Docket No. 52-021
MHI Ref: UAP-HF-08275

Subject: MHI's Responses to US-APWR DCD RAI No.92-1237 Revision 0

Reference: 1) "Request for Additional Information No. 92-1237 Revision 0, SRP Section: 19 – Probabilistic Risk Assessment and Severe Accident Evaluation," dated November 5, 2008

Figure 1 AL alloy casting processing simulation and experimental results from a CFD library in the CFD lab. Library.

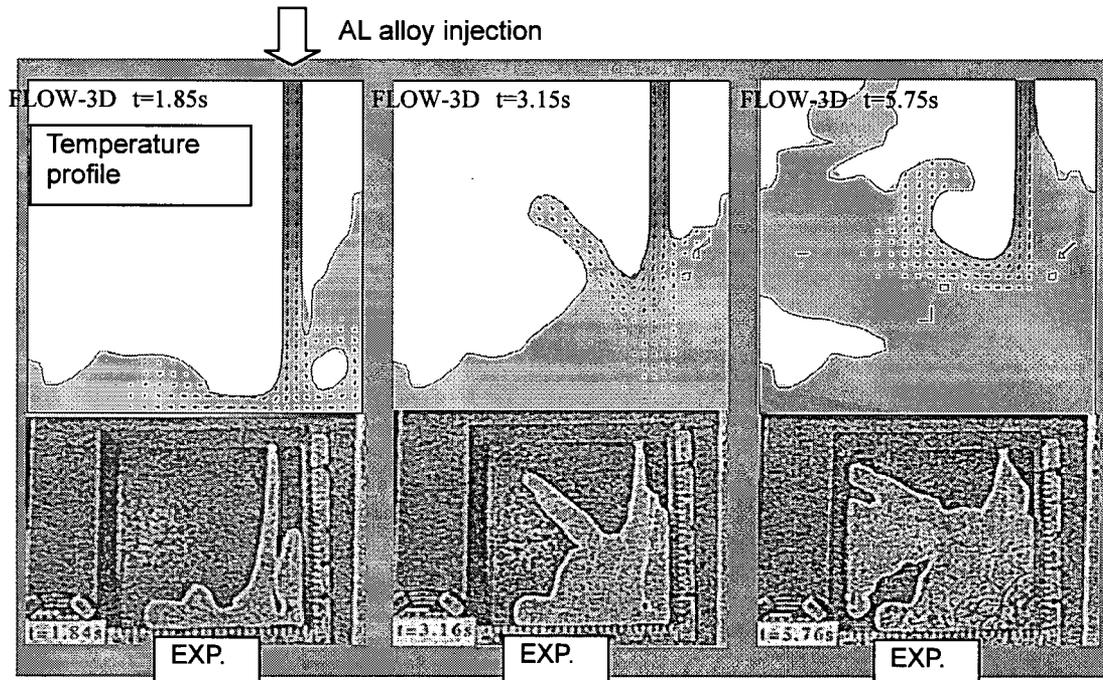
- (a) Provide references supporting the statements (Section 15.4.2.3 of the PRA) that it is “widely recognized” for its ability to evaluate the solidification behavior of molten materials, that the solidification model is considered having a good ability in its prediction, and that this model is expected to predict precisely the solidification form and spreading size of molten metal in the casting processes.
 - (b) Please describe what is meant by the volume of fluid (VOF) method in FLOW-3D code.
 - (c) In Section 15.4.2.3 please provide the references for “Previously performed studies show that the heat transfer coefficient of molten core and a reactor cavity....decreases to a value ranging from 1.76×10^2 to 4.40×10^2 ...as a result of formation of a crust layer.”
-

The verification results are shown in Figure 1. In this simulation, melting Al-alloy is injected horizontally into the cast box. As for the melting Al-alloy temperature decreases with progress of time and Al-alloy is solidified.

In this figure, it is observed that the Al-alloy spreading area and the shape of the Al-alloy by the FLOW-3D code accord with experiment results.

Figure 5. Schematic showing the calculation of area and volume fraction coefficients, A_f and V_f , for a solid object (shaded area) imbedded in a rectangular grid. The calculation of the source term for the continuity equation is shown for the central control volume.

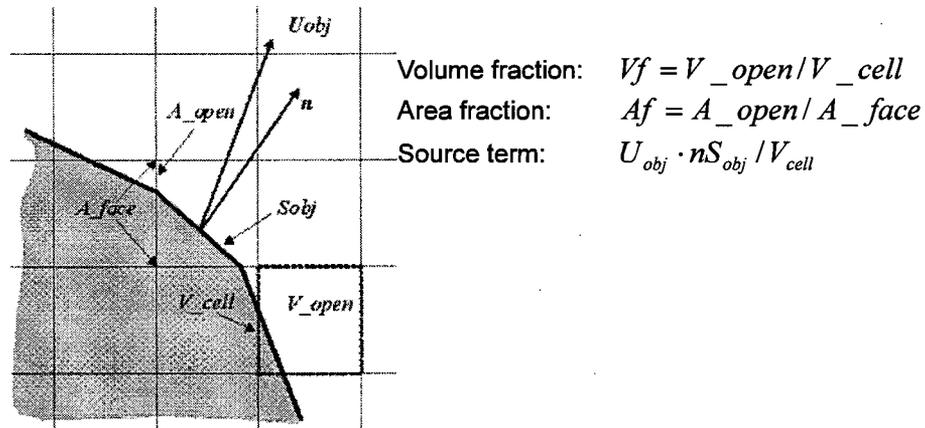
The FLOW-3D code is used to assess core melt spreading in the cavity. Please present a brief discussion of the special capabilities of this code. Describe the method of qualifying the code for this application in terms of validation and verification. Describe special modeling, if any, added to the code for the US-APWR analysis. Please provide the experimental validation basis of this code for application to debris pool spreading. In addition:

Equation (1) is solved using a high-order interface tracking numerical scheme that employs geometric reconstruction of the interface to maintain accuracy during its advection

Figure 19-172-1 Consideration of core melt cooling with or without cavity floor concrete erosion

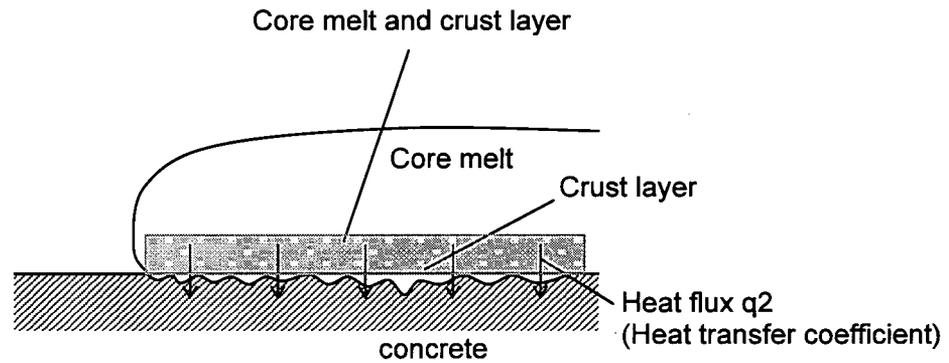
- (a) Please reference and summarize these previous studies.
 - (b) Discuss the conservatism of this assumption.
 - (c) Explain how this assumption is evaluated or included in the sensitivity studies performed for corium cooling and concrete erosion.
-

(b) Figure 19-172-1 shows schematic view of the core melt cooling behavior. When the crust layer is not formed, the core melt contacts directly with the concrete cavity floor. As a result, the cooling heat flux of the core melt is relatively large. On the other hand, when the crust layer is formed, the cooling heat flux of the core melt decreases. Because the thermal conductivity of the crust layer is smaller than that of the core melt.

In no crust formation case, the core melt is relatively rapidly cooled down and solidifies more quickly compared with that of the crust formation case. Therefore, as for the core melt coolability and spreading behavior, the PRA analysis assumed no crust formation for the FLOW-3D code is considered conservative evaluation.

Figure 19-182-1 The Movable Neutron Detector Guide Structure

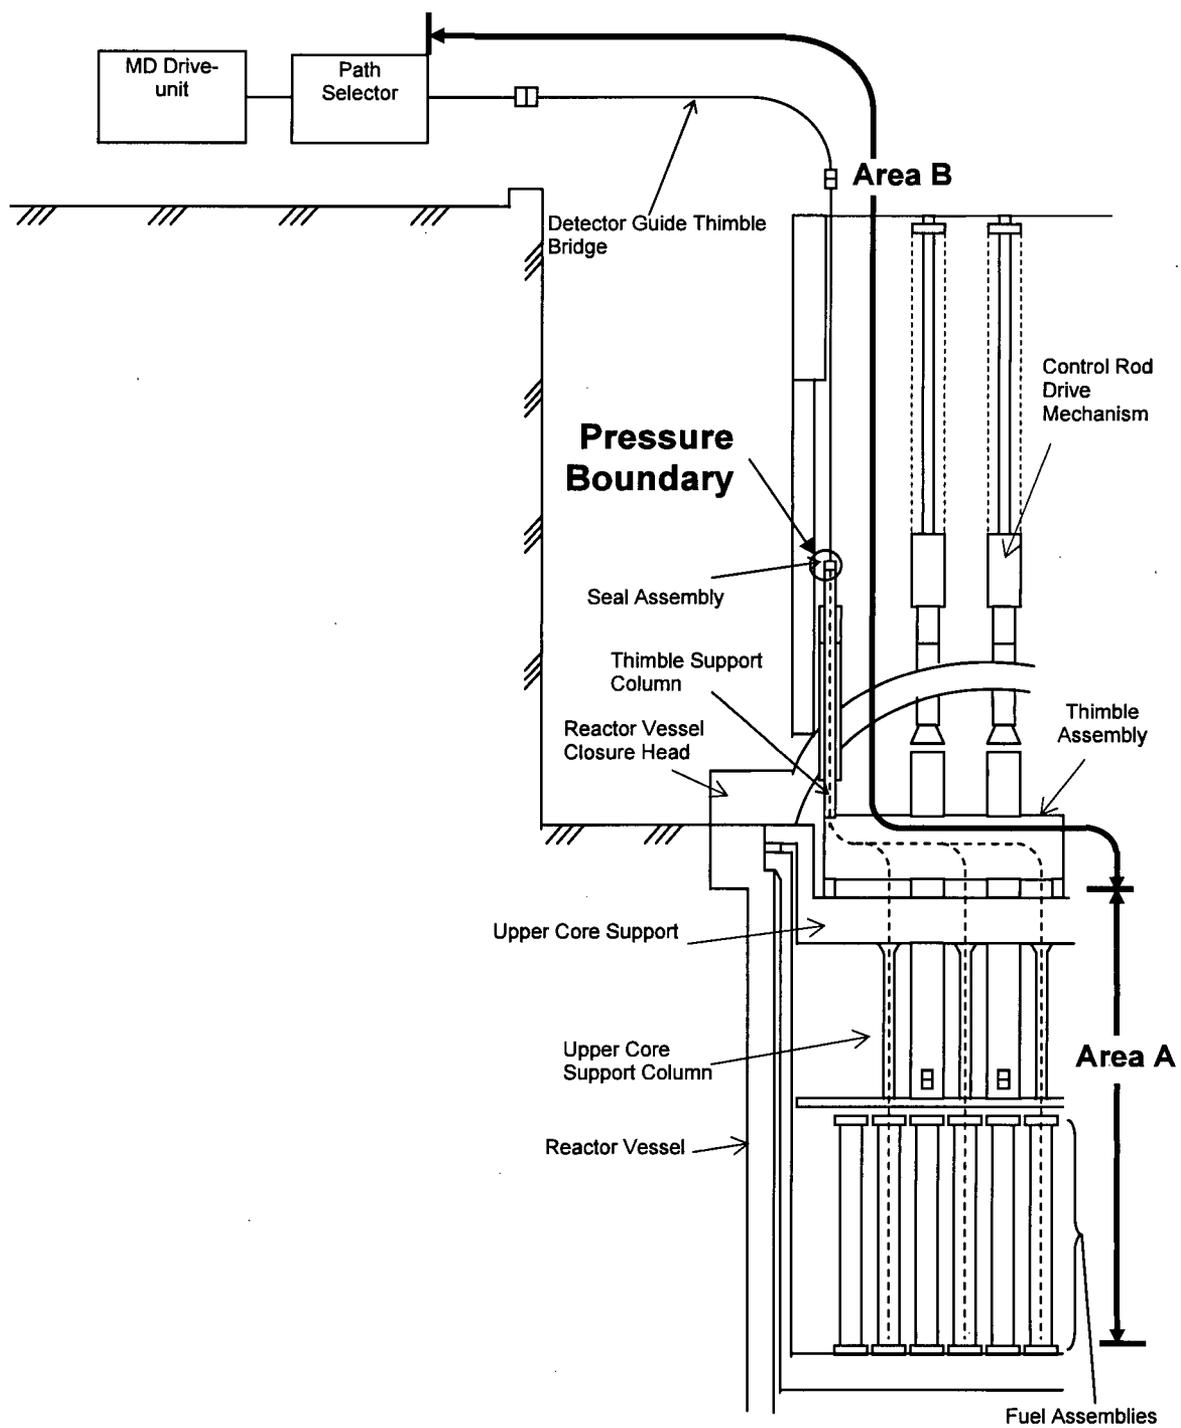
Please provide the following design information related to the in-core instrument tubes:

- (a) The schematics of the moveable detector and the thermocouple are shown in Figure 19-182-1 (The Movable Neutron Detector Guide Structure) and Figure 19-182-2 (The Core Exit Thermocouple Guide Structure).

Figure 19-182-4 The location inside the containment (1/2)

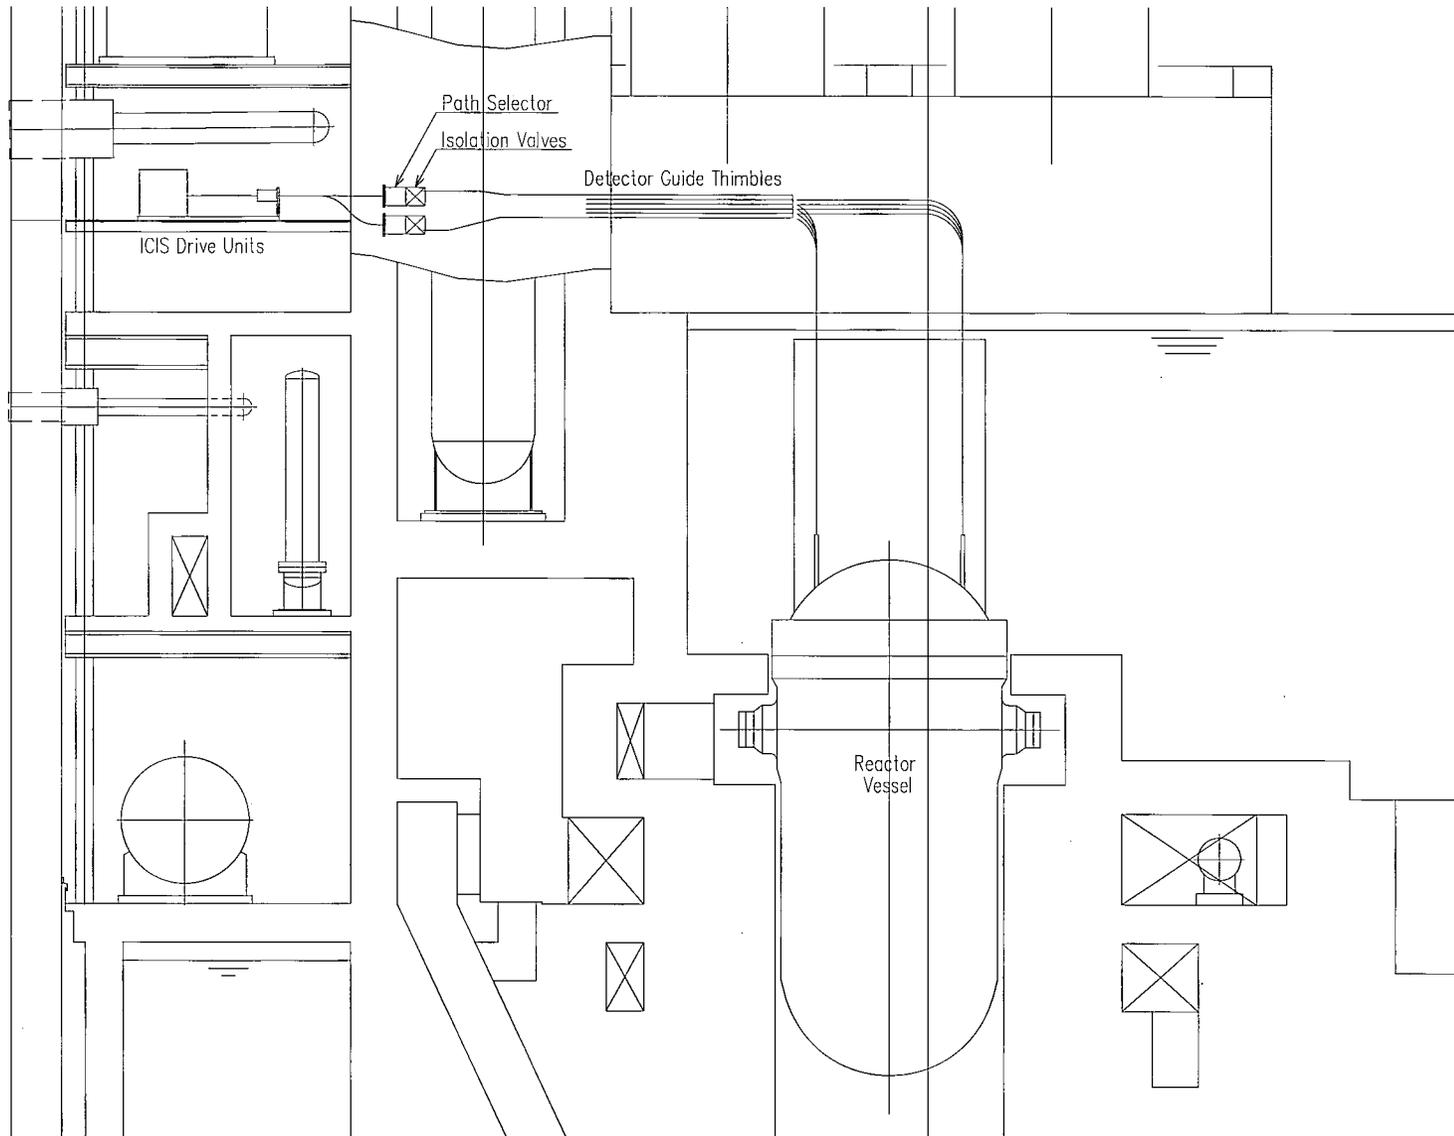
- (e) A schematic of the in-core instrumentation guide tubes configuration, their location of entry into the reactor pressure vessel, and the location of entry into the instrumentation room inside the containment. This information should also show the actual location inside the containment (to be accompanied by a drawing of the containment marking the location of the instrumentation room).

(e) and (f) The actual location inside the containment is shown in Figure 19-182-4 (The location inside the containment). There is not the instrumentation room in the containment.
